City of Avondale Estates
Planning Architectural Zoning Board
Staff Review, Variances *

November 17, 2025, PAZB Meeting

Applicant: 278 Oak Holdings LLC: Jetha Wagner, Avila Development

Property Address: 136 Laredo Drive, 2968 Parry Street, 147 Oak Street, 2950 Franklin Street, and 2556 Franklin Street (Oak Parcel)

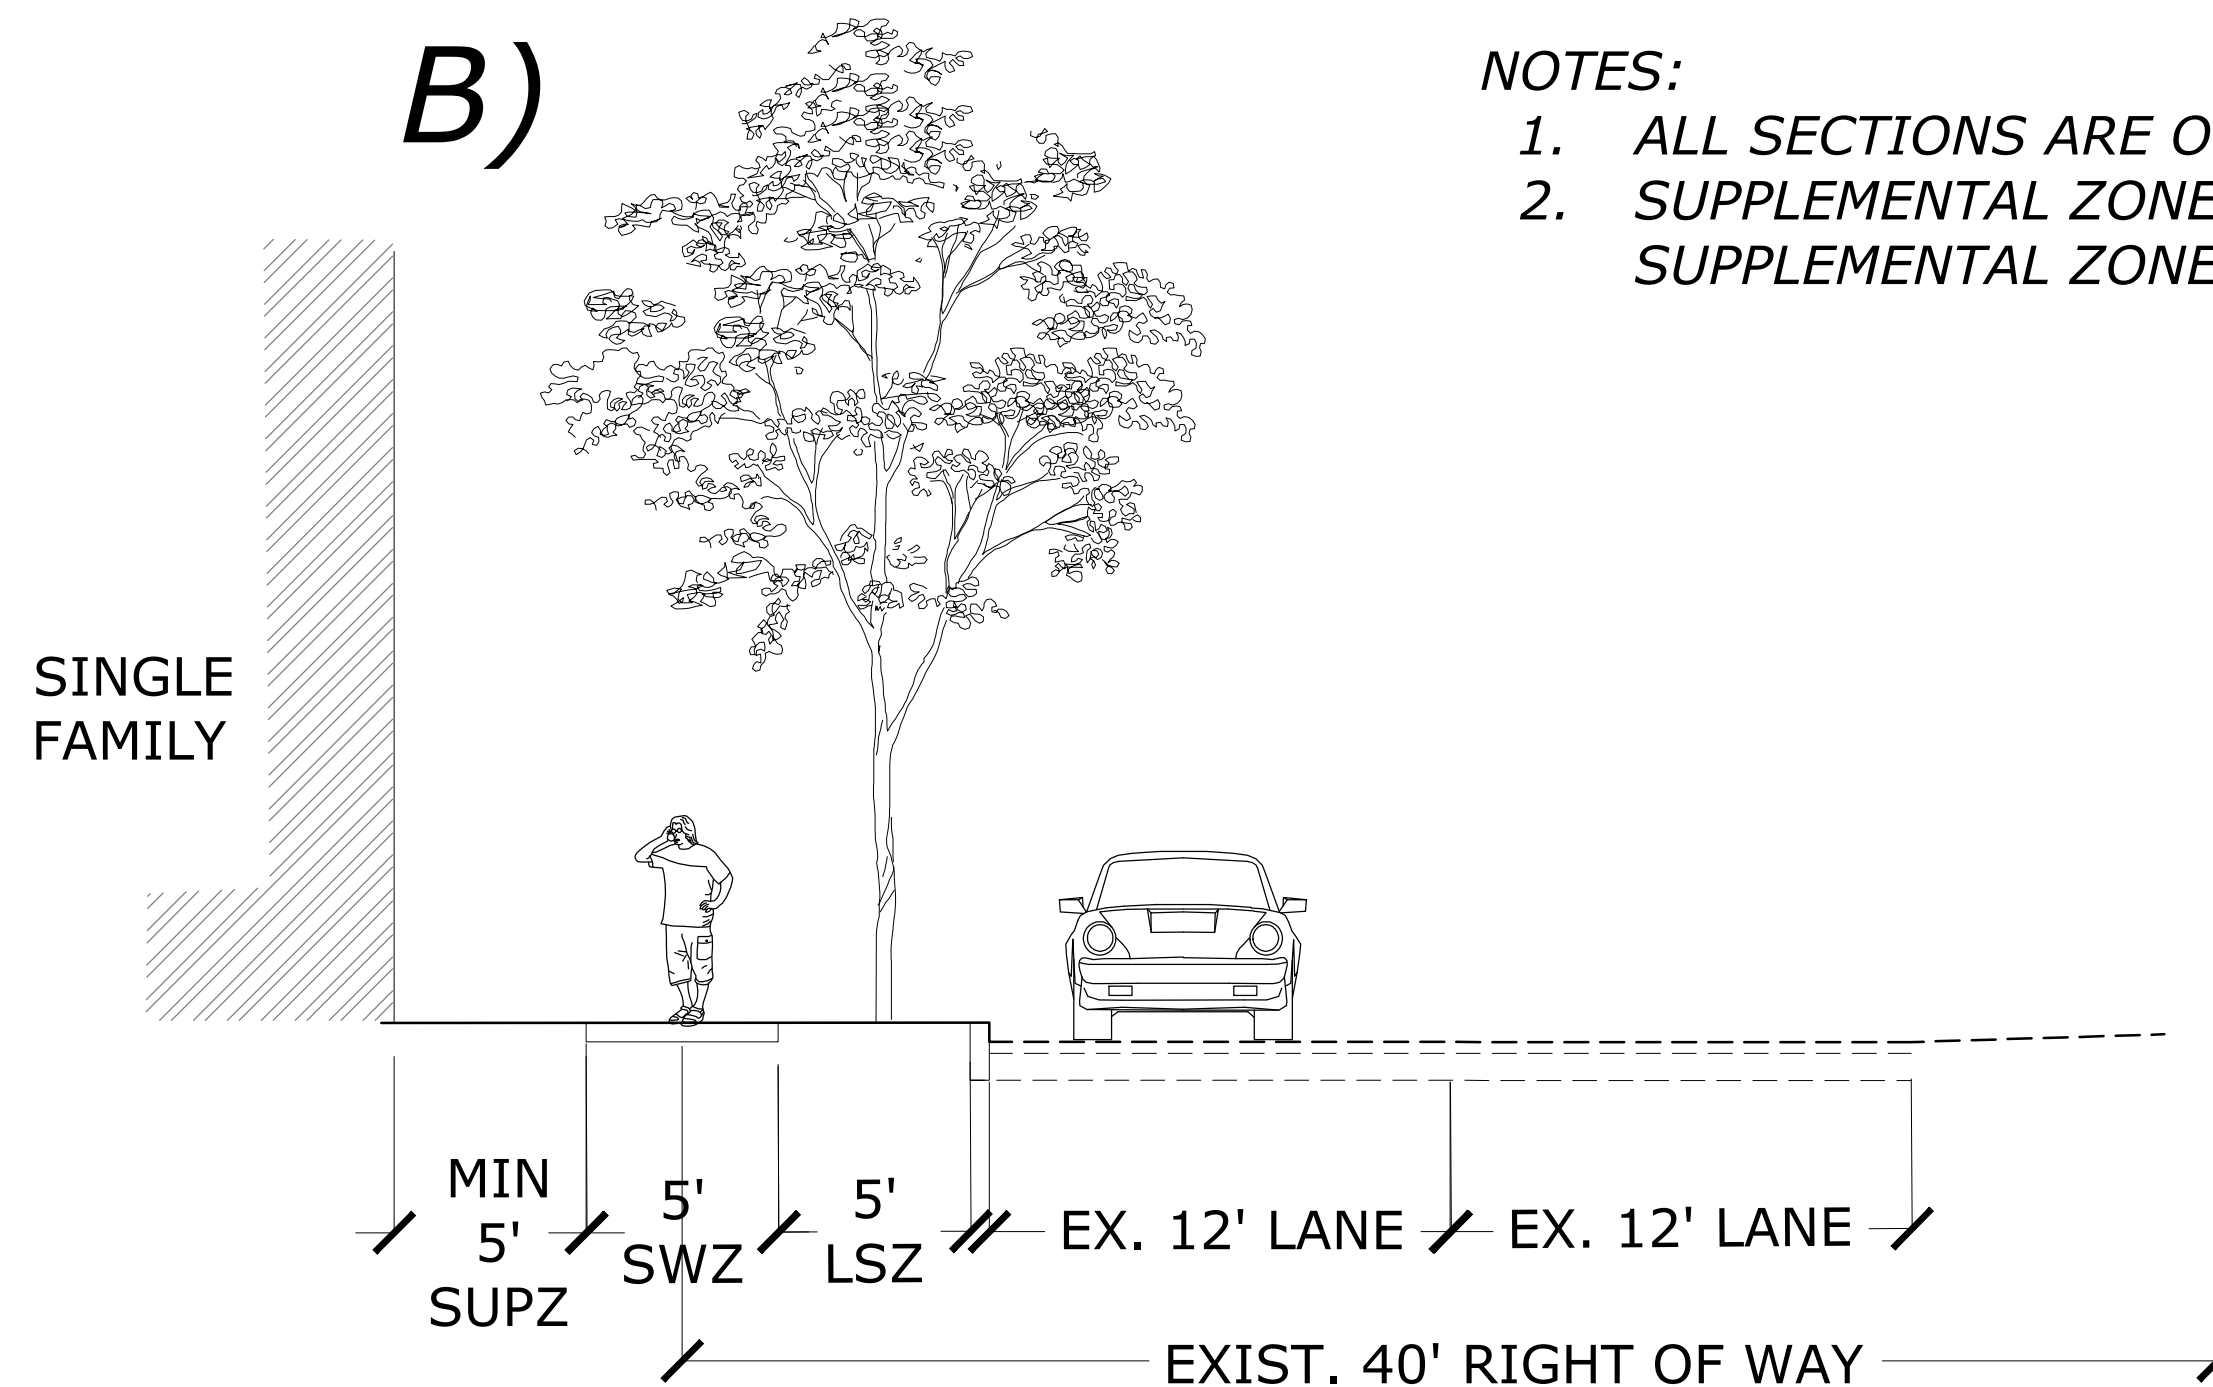
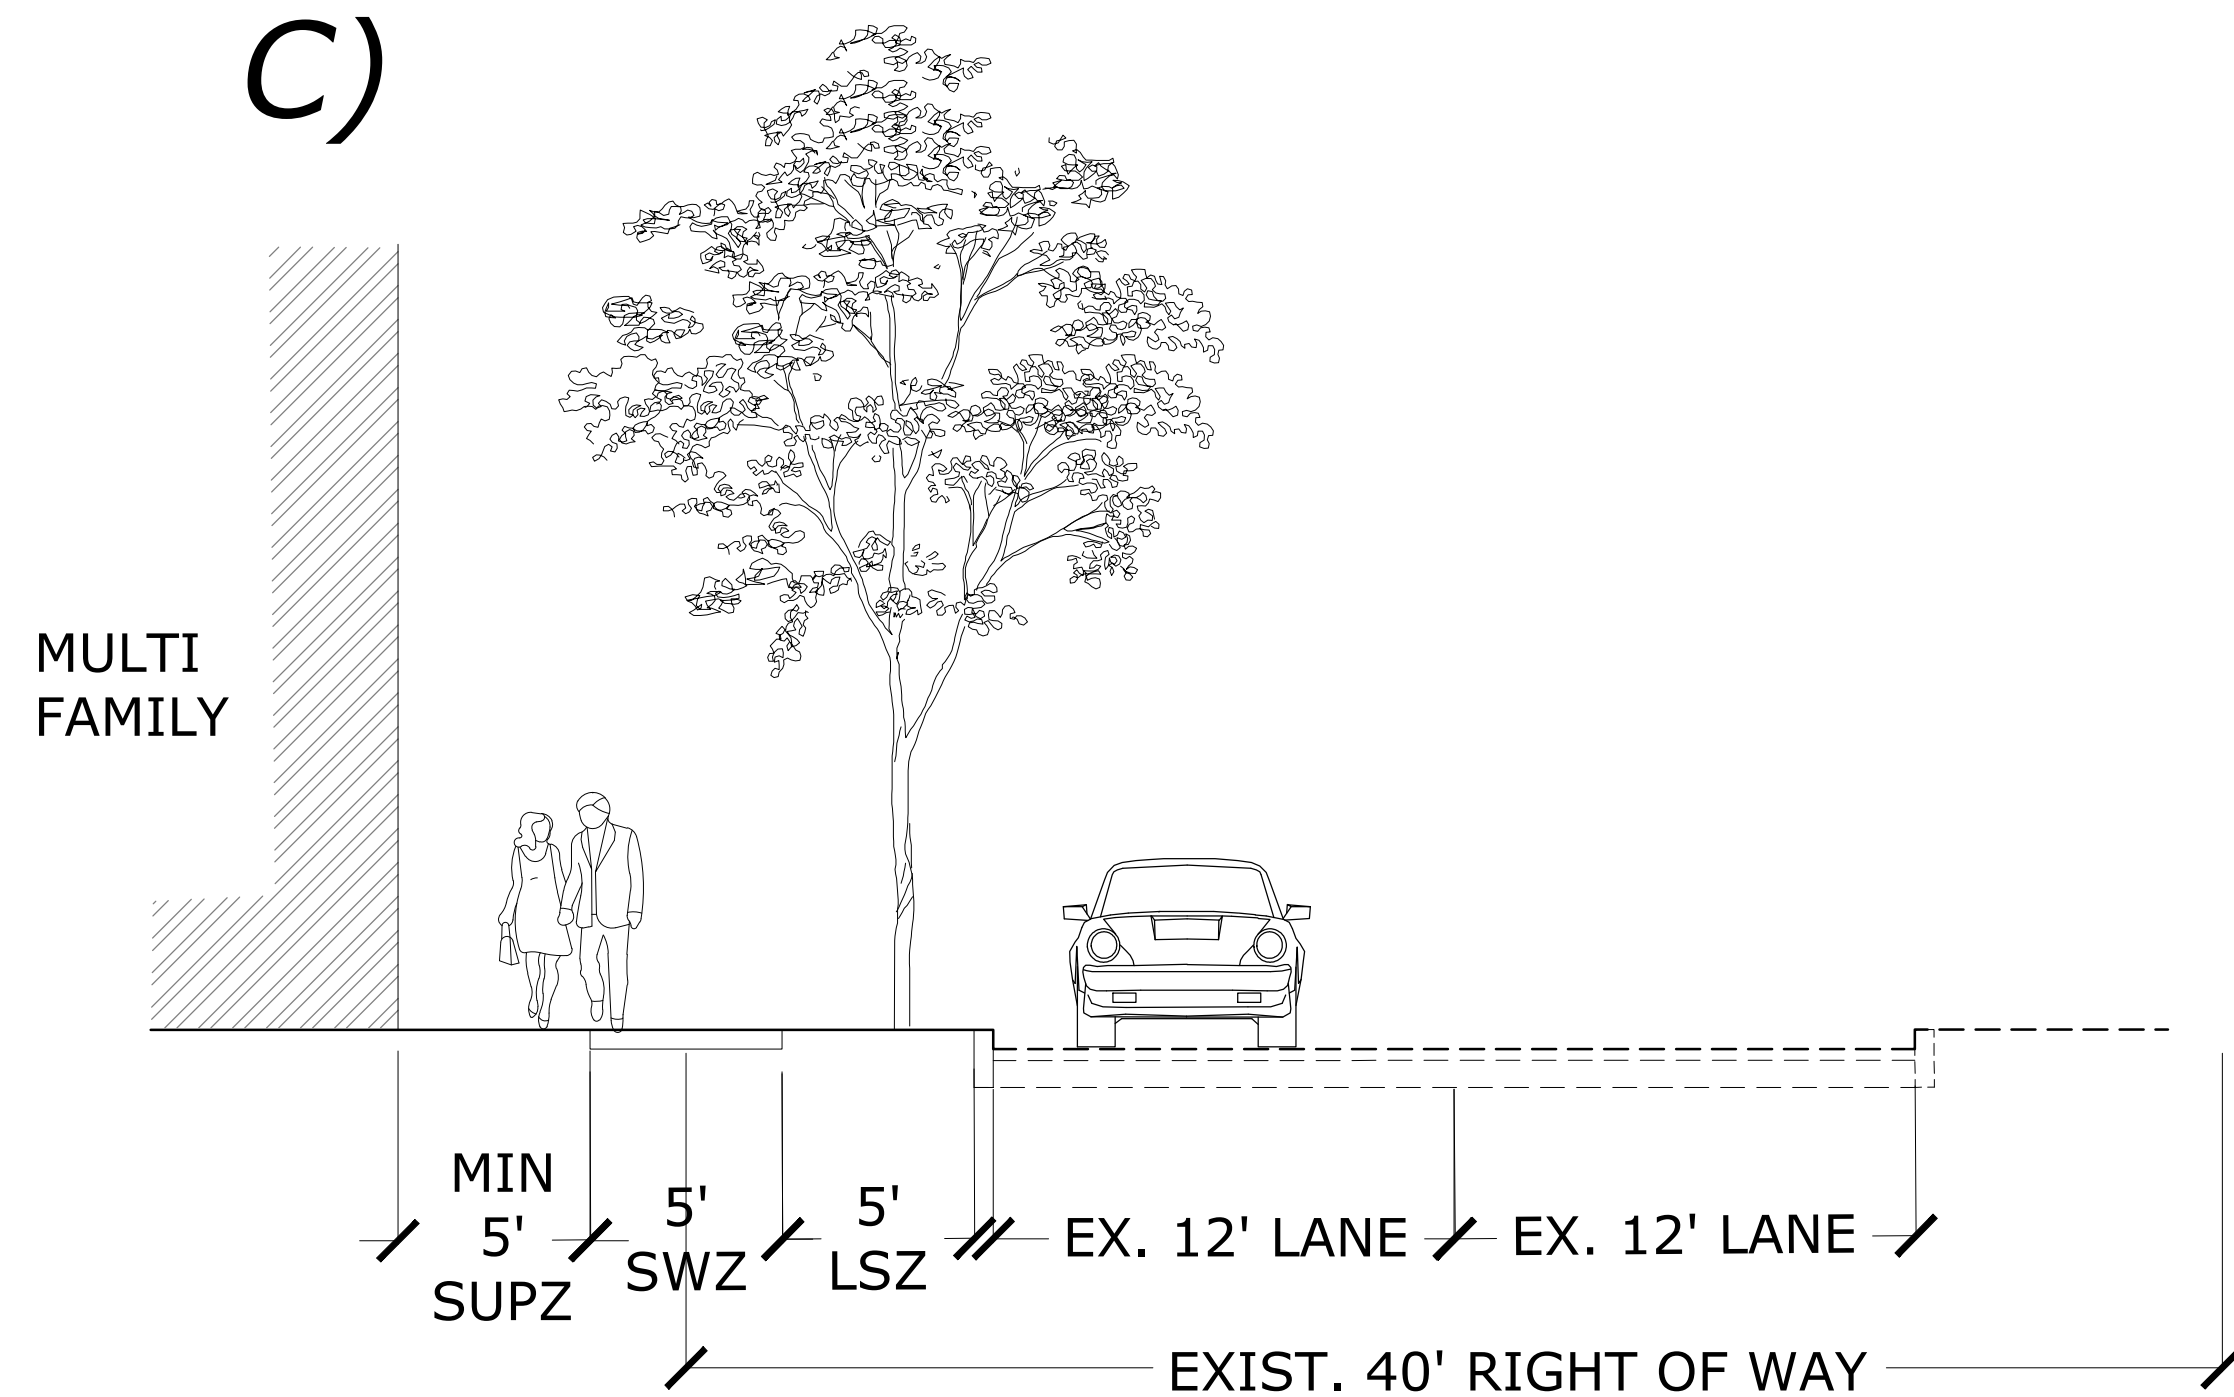
FROM: Figure 21-3.2.8.B.4.d and Table 3.2.8.E reduce type D street section from 40' ROW and 5' SUPZ to building face.

FROM: Figure 21-3.2.8.B.4.c and Table 3.2.8.E reduce type C3 street section from 40' ROW, 2' additional LSZ and 5' SUPZ to building face.

FROM: Figure 21-3.2.8.B.4.c and Table 3.2.8.E realign type C3 street section from 40' ROW, 2' additional LSZ and 5' SUPZ to building face.

FROM: Figure 21-3.2.8.B.4.d and Table 3.2.8.E reduce type D street section from 40' ROW and 5' SUPZ to building face.

FROM: Figure 21-3.2.8.B.4.c and Table 3.2.8.E reduce type C2 street section from 40' ROW, 5' SWZ, and 5' SUPZ to building face.
